Staff Summary Report

Development Review Commission Date: 03/22/11

SUBJECT: Hold a public meeting for a Development Plan Review for THE RETREAT AT 1000 APACHE located at 1000 East Apache Boulevard.

DPR11038 – Development Plan Review including site plan, building elevations, and landscape plan.

UNDERGROUND PARKING PLAN

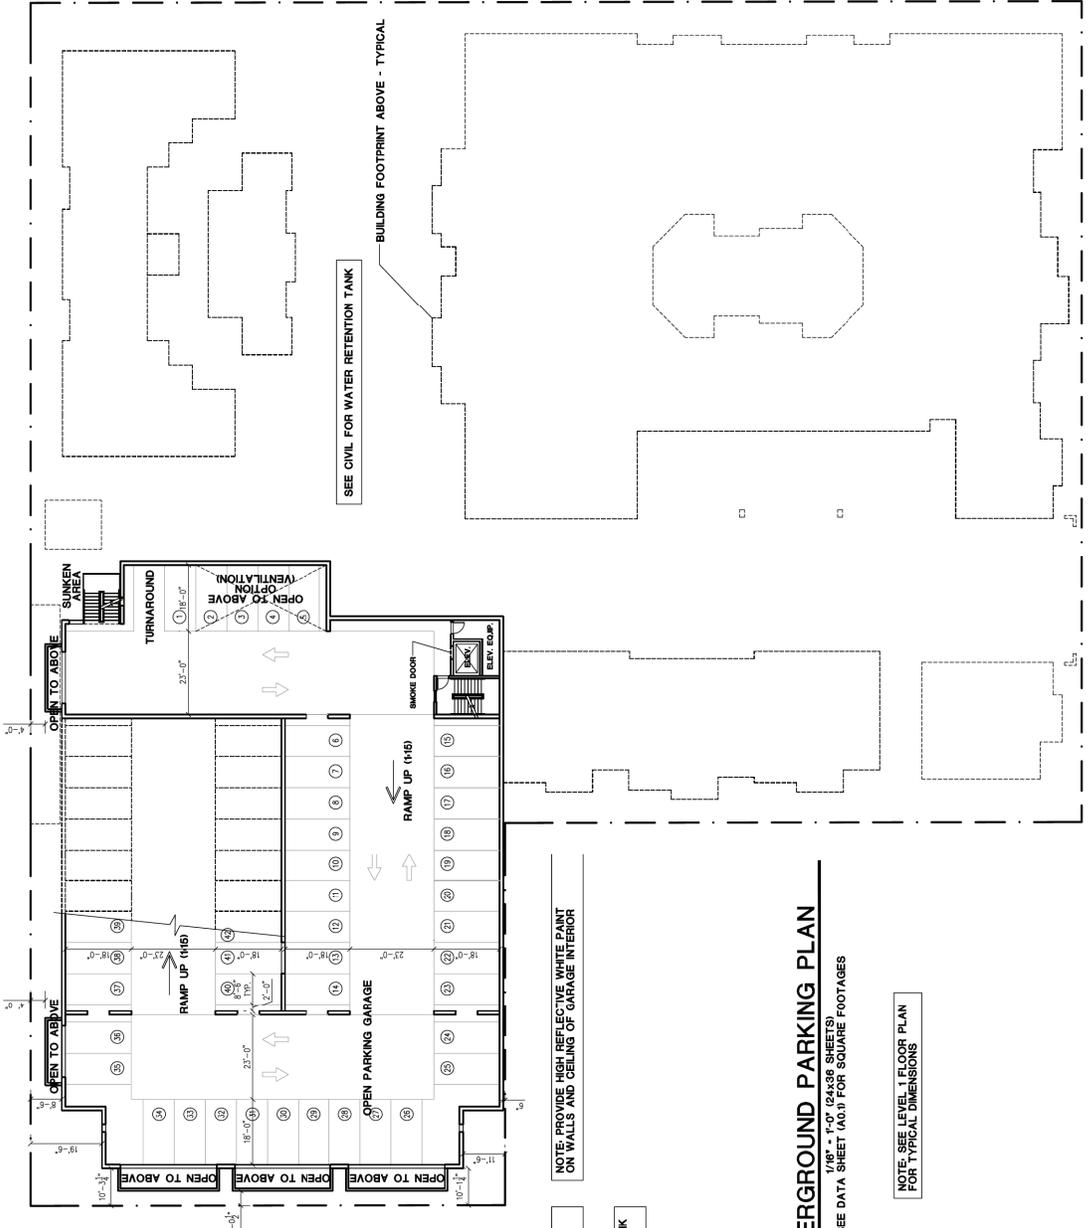
- b. At the ends of dead-end drive aisles, provide a designated, clearly demarcated turn-around space, minimum 8'-6" clear in width and positioned at 90 degrees to the drive aisle.

- c. Provide a minimum 2'-0" additional width for parking spaces that are adjacent to a wall.
 - d. Paint interior wall and overhead surfaces in garage levels with a highly reflective white color, minimum LRV of 75 percent.

THE RETREAT @ 1000 APACHE
ARIZONA
EXTERIOR ELEVATIONS
-- PRELIMINARY PLANS --

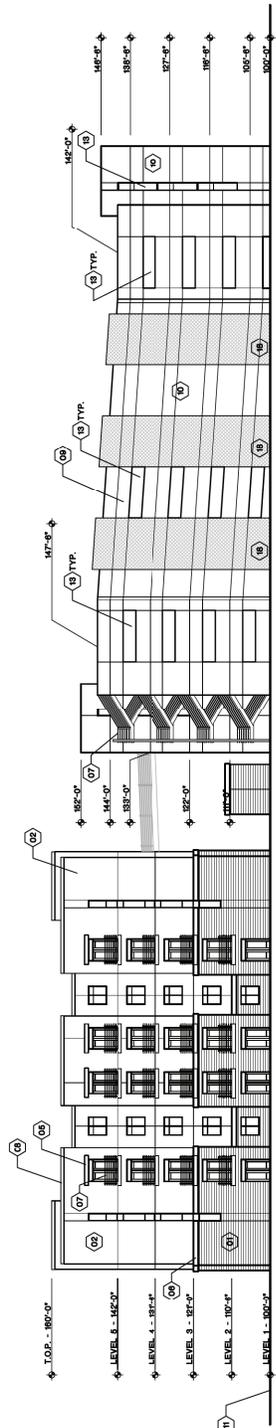
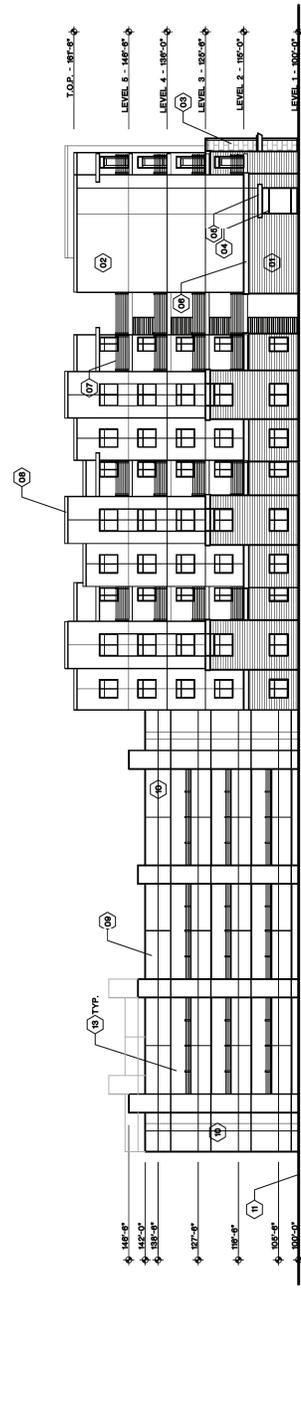
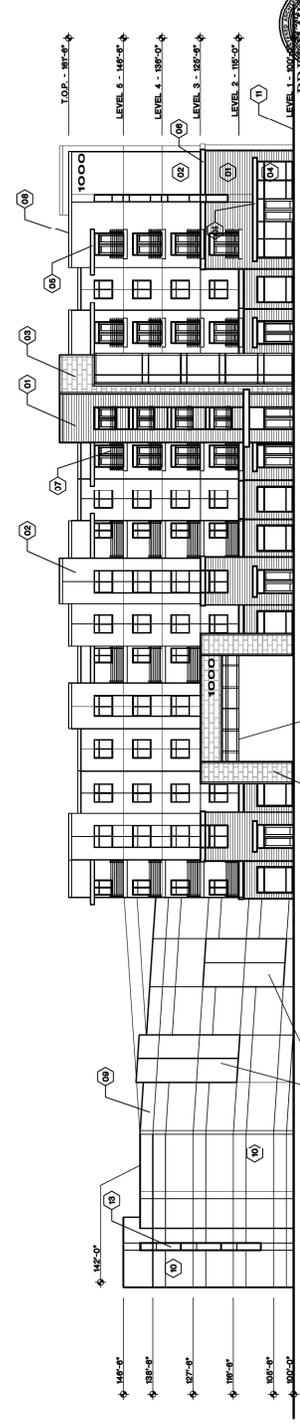
9. On garage, design lattice without foot or hand holds and stand the lattice away slightly from the tilt slab concrete structure or provide lattice depth to foster vine growth.

10. The materials and colors are approved as presented including Kwal Howells Holland LRV 51 and Dog Paw LRV 21. Provide substitute paint color Kwal Howells Spray River LRV 69 for Kwal Howells Deer Feather LRV 85. Identify manufacturer and type of aluminum cladding. Integral color concrete masonry unit (Amcor Sagewood) is acceptable as presented. Submit any additions or modifications for review during building plan check process.

11. Provide secure roof access from the interior of the buildings to each roof. Do not expose roof access to public view, including ladders between adjacent roofs. Provide continuous parapets. Do not expose any portion of roof top equipment.

PRELIMINARY LANDSCAPE PLAN
 SCALE 1" = 20'
 GRAPHIC SCALE FEET
 0 20' 40'

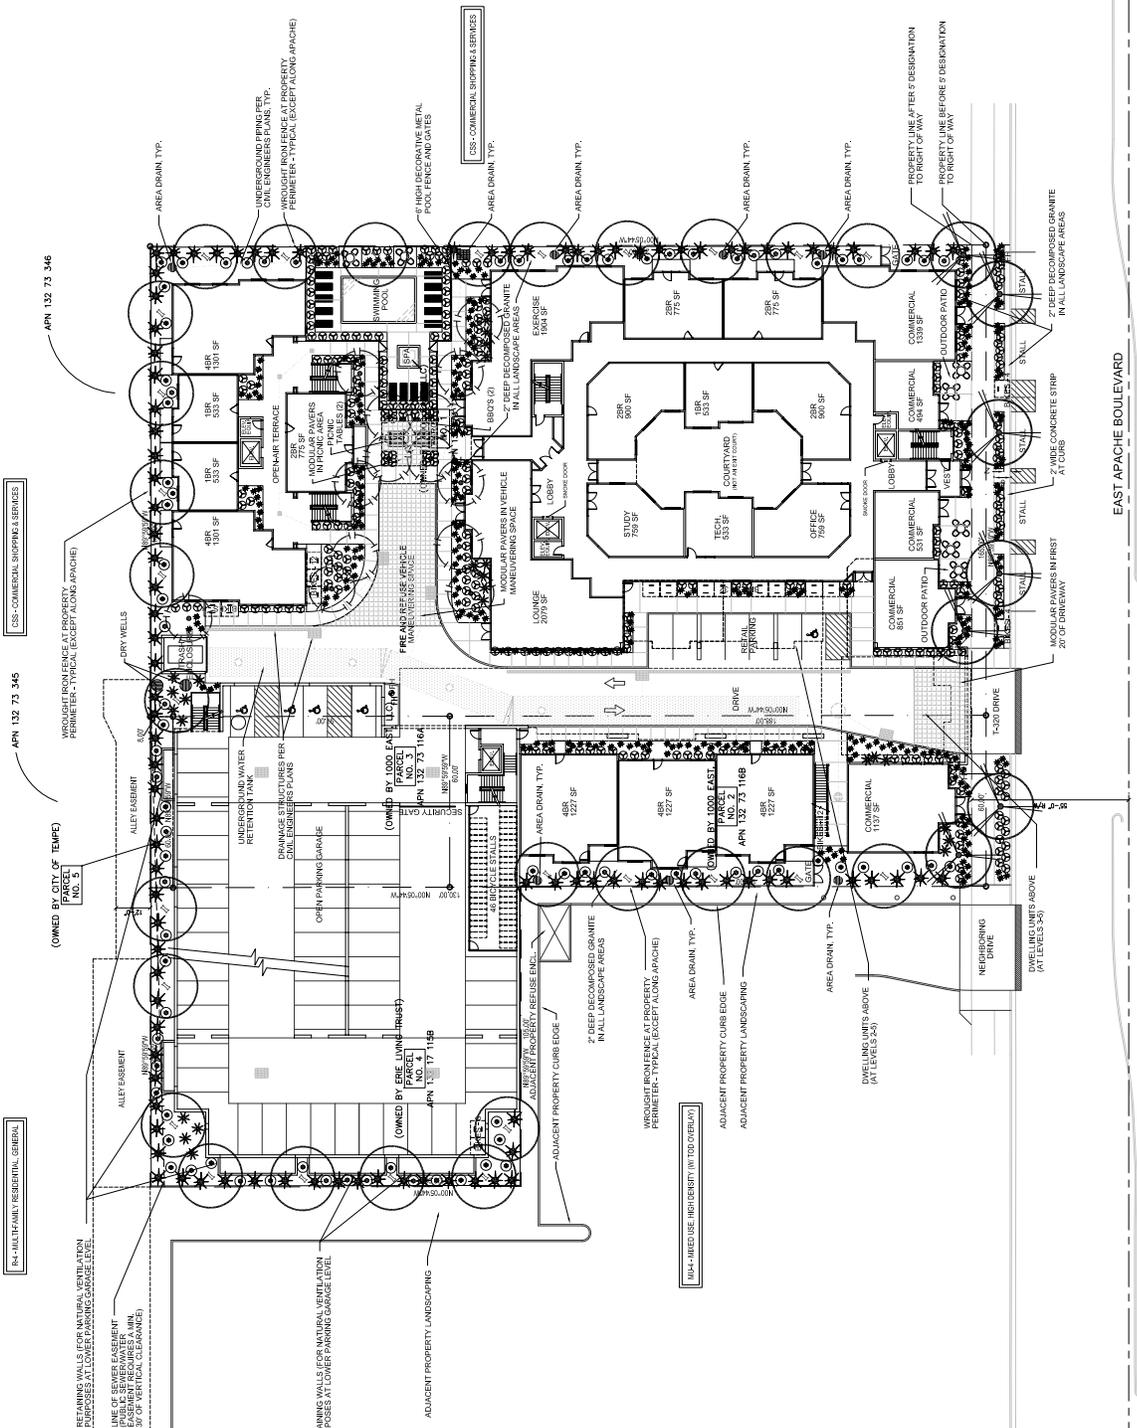
15. Landscape development standards as listed in ZDC Sec. 4-701 through 4-706 apply to this Mixed-Use District.
16. Select vine for lattice on garage that will thrive on northern orientation.

17. Maintain tree buffer as presented along east, west or north property lines, except reposition trees at north of garage to stay clear of the sewer easement extension. Coordinate position of subsurface retention structure along perimeter with tree placement so the trees are not sacrificed during construction document plan check process.

18. Check site and frontage for existing native and protected plants. Remove Mexican palo verdes and other non-protected trees where these occur on site. Reuse existing mesquite in Apache Boulevard frontage landscape or remove tree for another location in accordance with State Agriculture Department standards. If mesquite is salvaged or demolished, file State Notice of Intent to Clear Land with the Agriculture Department and include copy of the Notice in the City's construction document submittal.
